SUBJECT: Application G- 15173

Proposed Permit Conditions: Application G-15173

WATER RESOURCES DEPARTMENT MEMORANDUM

Date: September 4, 2000
To: Groundwater/Hydrology
From: Ivan Gall – Grants Pass
Subject: GW Application **G-15173**

WELL #2 G-15173

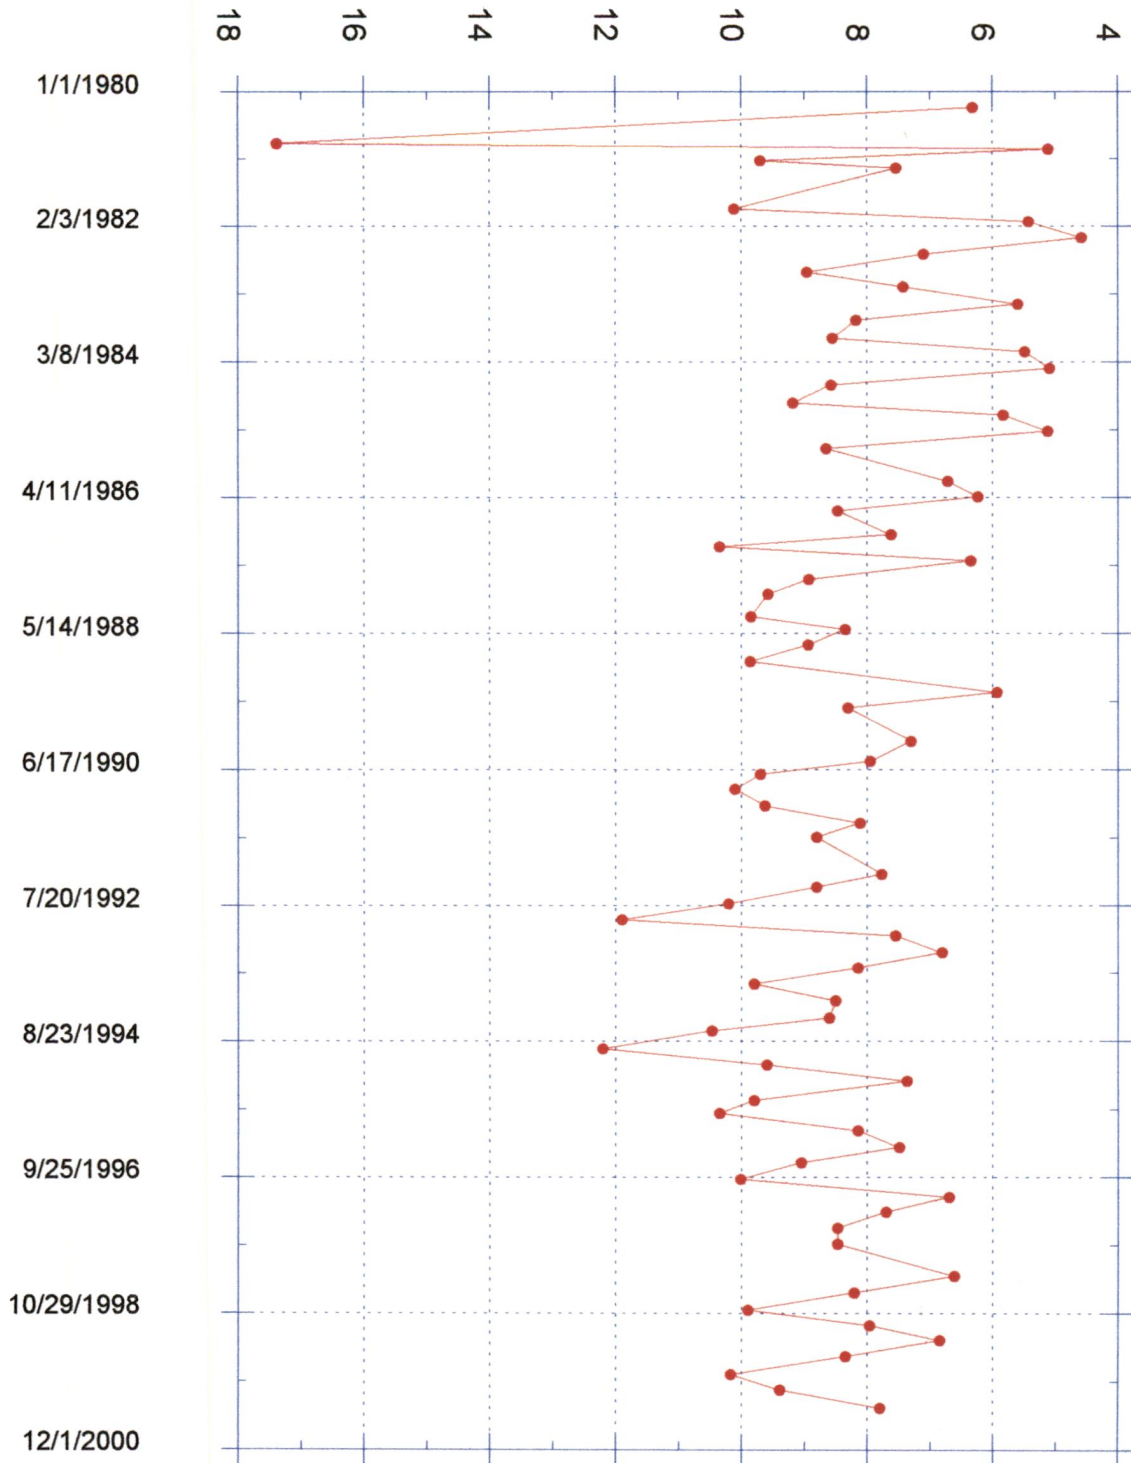
$\Delta S_{(100-10)} = 5.37$
 $Q = 60$

$T = 424 \frac{ft^2}{d} - MST$ $Q = 60 gpm$

$T = \frac{2,303(60 \frac{gpm}{min})}{5.37 \cdot 4 \cdot \pi} = 2.05 \frac{ft^2}{min} (7.48) (\frac{1440}{1}) = 394 \frac{ft^2}{d}$

State Observation Well # 261
Steve Miller Shop Well, 38S-5W-14

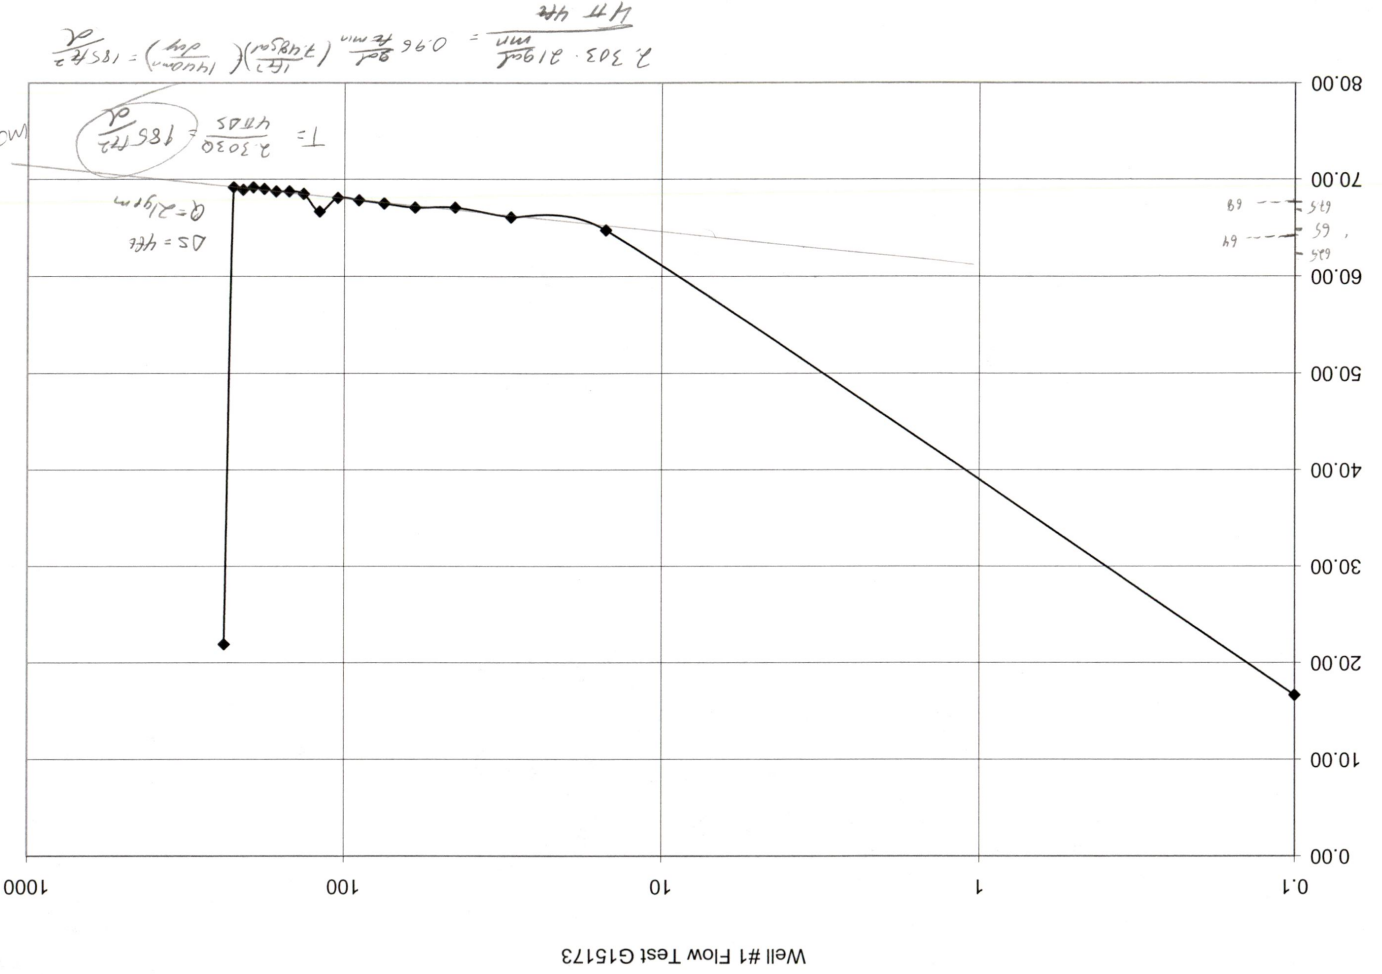
Some long-term water level data from a state observation well (#261, Steve Miller Shop Well) exist for this area (hydrograph is attached). This well is located approximately 6 miles from the subject wells. Water level data collected at well #261, from approximately 1981 to present, indicate a seasonal fluctuation of approximately four to six feet, with no long-term water level declines. Unfortunately, this data is of limited value due to the distance between the subject wells and well #261, and the uncertainty of a well log for well #261.
